CALCULATION NO. NED-M-MSD-49				PAGE 1 OF 8	
<input checked="" type="checkbox"/> SAFETY RELATED			<input type="checkbox"/> NON-SAFETY RELATED		
<p style="text-align: center;"><u>CALCULATION TITLE</u></p> <p style="text-align: center;">Dresden LPCI/Core Spray NPSHA Evaluation w/o Overpressure - Post DBA-LOCA</p>					
EQUIP NUMBER(S)		STATION/UNIT	SYSTEM		
2(3) - 1502A/B/C/D 2(3) - 1401A/B		Dresden 2 & 3	LPCI/Core Spray		
REV.	CHRON #	PREPARER	DATE	REVIEWER	DATE
	0 198390	<i>Harry Kula</i>	2/22/93	<i>Don K. Lee</i>	2/22/93
				<i>Paul E. Ding</i>	2/22/93

Calculation No. NED-M-MSD-49 Rev 0
Dresden LPCI/Core Spray NPSH Evaluation w/o Overpressure-Post LOCA

Subject: Dresden LPCI/Containment Cooling System

DRESDEN LPCI/CONTAINMENT COOLING SYSTEM EVALUATION

LPCI/CONTAINMENT COOLING SYSTEM
PROCESS DIAGRAM

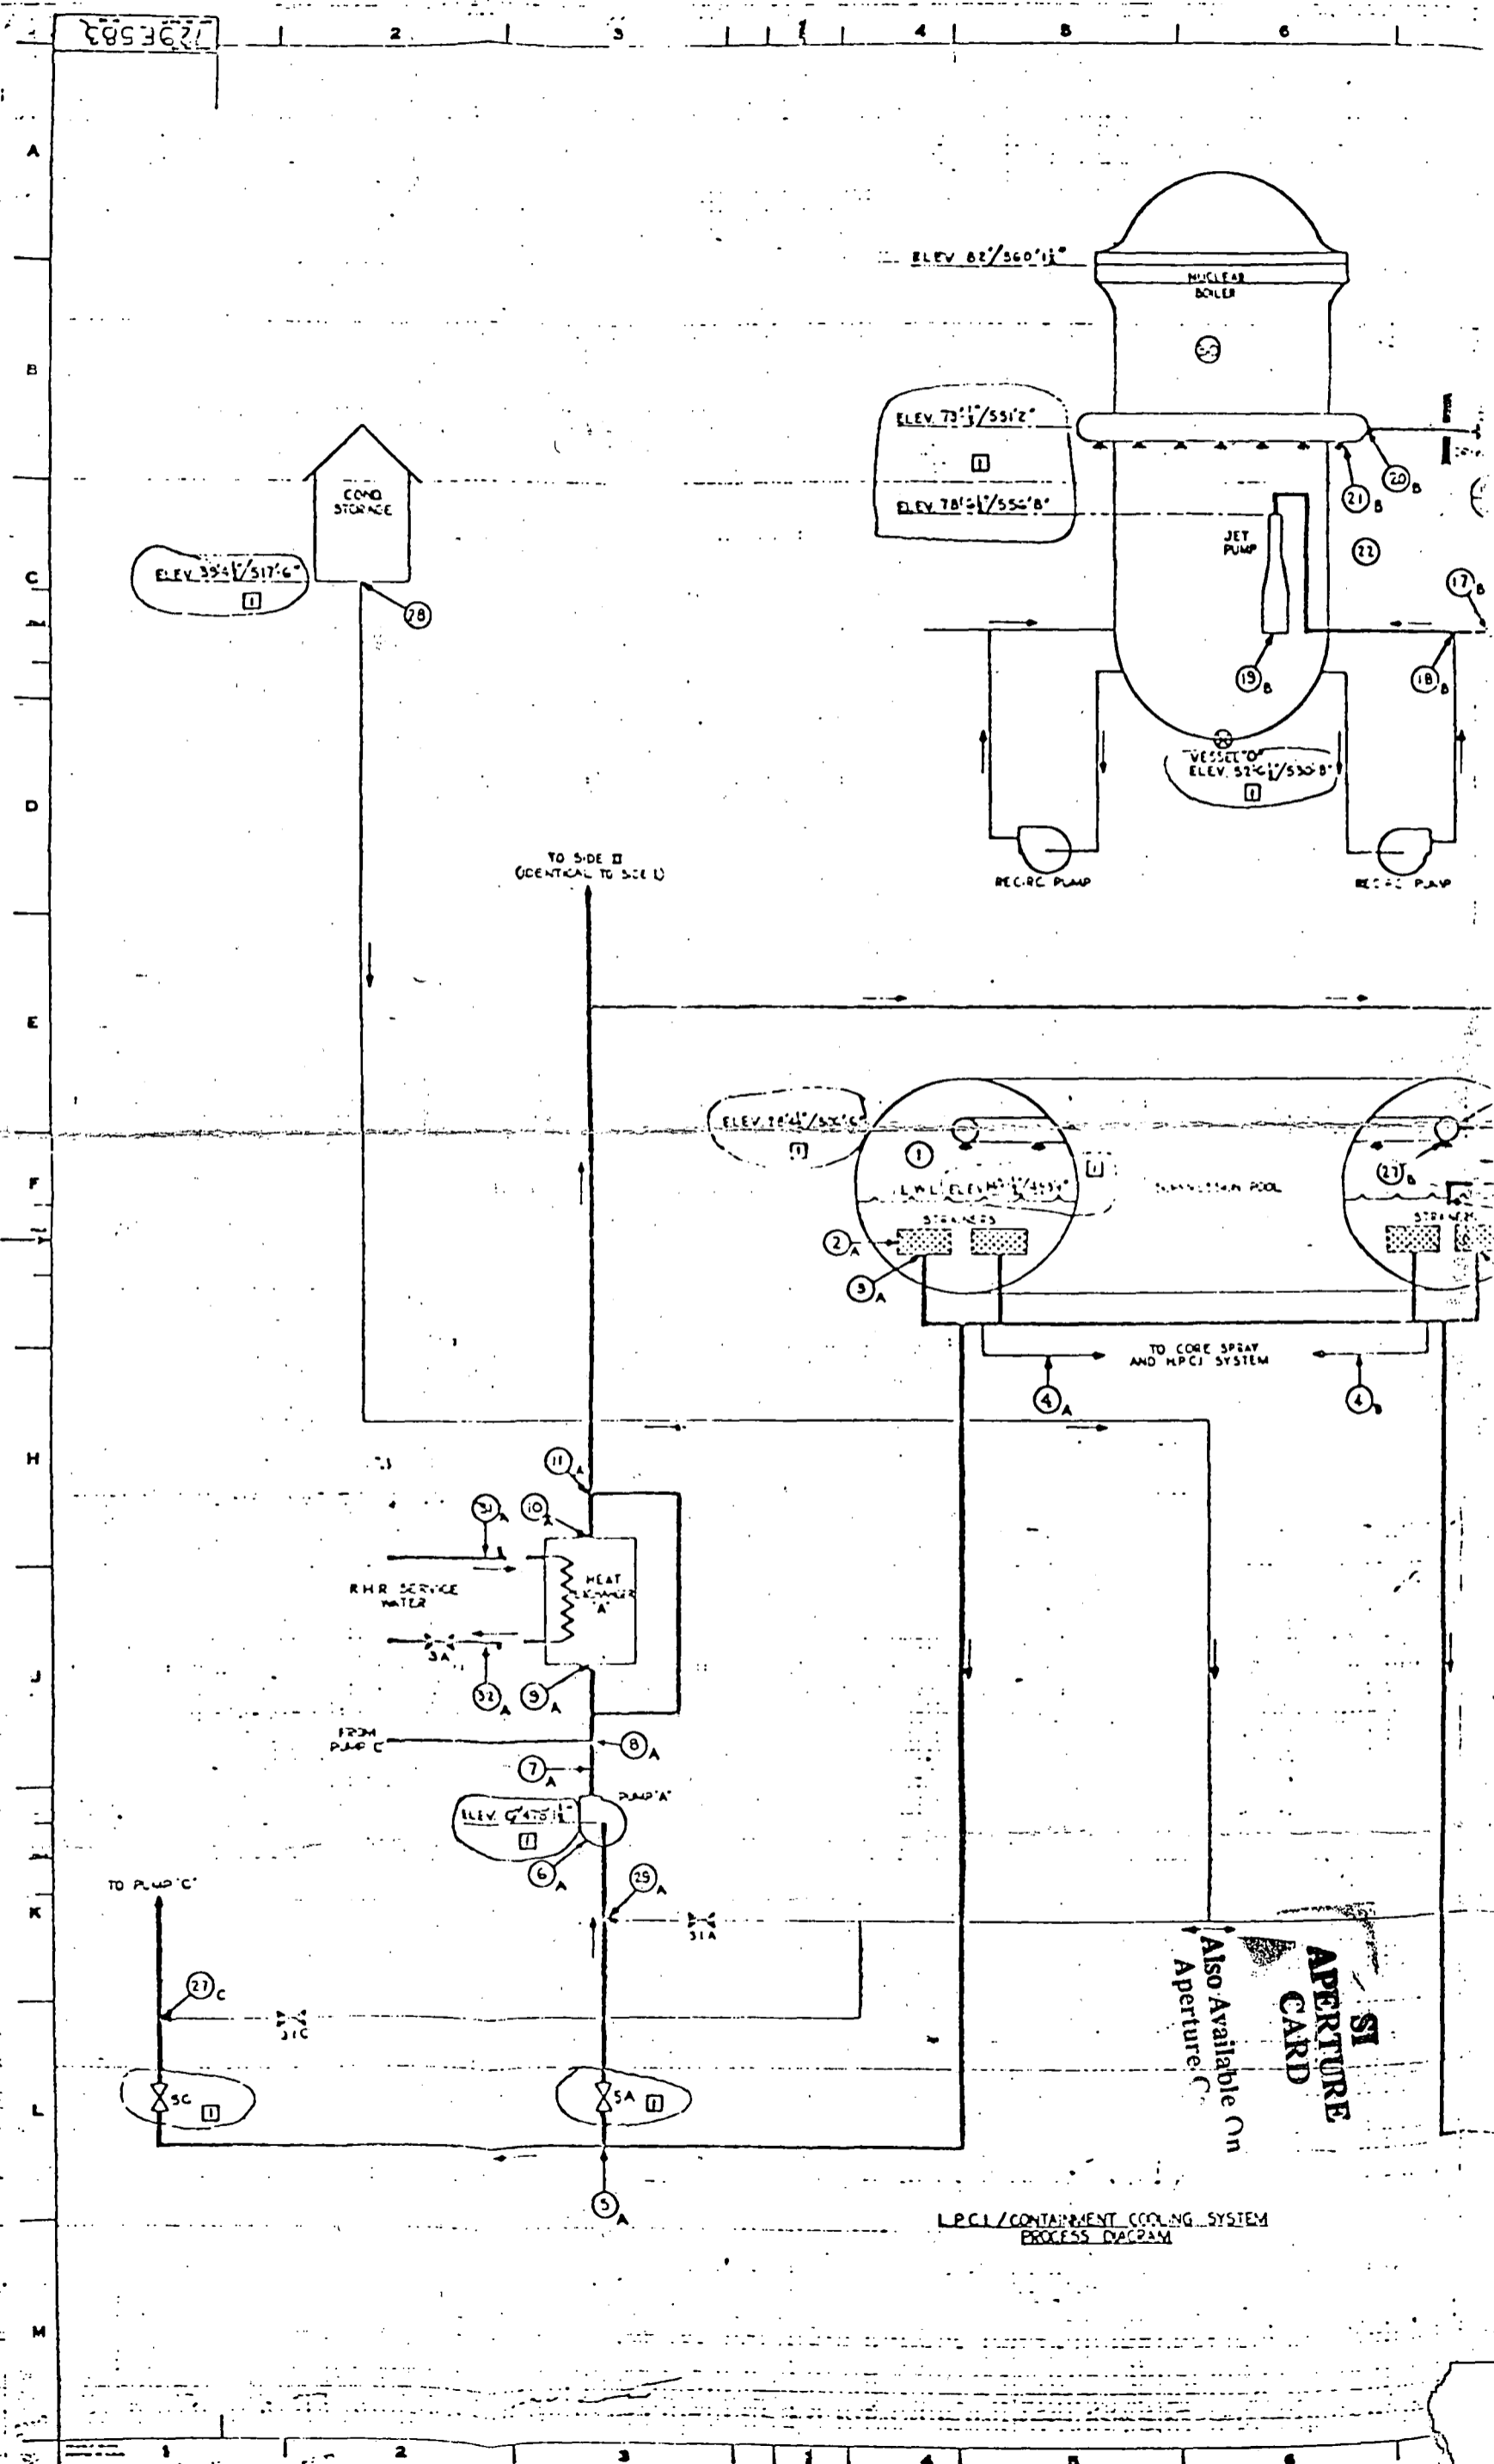
In light of the above, GENE elected to use current methodology to establish Containment Cooling HX performance under the conditions shown in "Modes B and C" in GE Drawing 729E583 (Reference 3). This effort involved construction of a heat exchanger performance analysis model from known parameters listed on the original Heat Exchanger Data Sheet and GE approved, fluid heat transfer coefficients. Calculations based upon this new model yielded terminal temperatures and heat transfer rates that were inconsistent with the original Heat Exchanger Data Sheet and with Modes B and C of the above drawing. However, the calculation results showed that the original methods did in fact reduce the value of "U" (Overall Heat Transfer Coefficient) from Mode B conditions to Mode C, in order to reflect the large scale reductions in flow, both on the tube and shell side of the heat exchanger. The results of these new calculations for Mode C flow conditions are shown in Reference 4 attached.

To resolve the above inconsistency between new calculations and the conditions shown on the Heat Exchanger Data Sheet, GENE contacted the original heat exchanger manufacturer (now Senior Engineering). These discussions led to the manufacturer's search of his records, both in Los Angeles, California and in Berlin, Wisconsin. Again, these data recovery efforts were not successful. The manufacturer agreed to run a set of calculations, using its current proprietary codes, in an attempt to duplicate the heat exchange rates and terminal conditions shown on the Heat Exchanger Data Sheet. These efforts also showed inconsistency with the original data sheets, however, the results closely agreed with those produced by GENE methods.

CECO elected to confirm the current capability of the original Heat Exchanger. This effort was undertaken to conclusively show that DBA maximum suppression pool temperature margins (for LPCI pump NPSH purposes) are conservative. The effort utilized the results of the more realistic decay heat calculation methodology (ANS 5.1) to compare with the results of the older (May-Witt) method used in the original design of the Dresden units. The use of ANS 5.1 decay heat in evaluations of the long-term containment pressure and temperature response with power uprate was presented to the NRC in a submittal (Reference 5) which has been approved by the NRC. This comparison shows that in the post-DBA time frame of maximum suppression pool temperature, decay heat is at least 15% less than the value used in the original design (84.5E6 BTU/hr). Hence, given the currently calculated heat exchanger heat transfer rate of 77E6 BTU/hr (at Mode C conditions) for the original heat exchanger, and a more realistic decay heat rate generation, the maximum suppression pool temperature, post DBA, would be less than the 180F maximum temperature specified in Mode C of GE Drawing 729E583 (Reference 3). In addition, since Mode C specifies the use of one Containment Cooling Heat Exchanger, one Containment Cooling Service Water pump, and one LPCI pump, it is concluded that this equipment combination is adequate for post-DBA suppression pool containment cooling purposes.
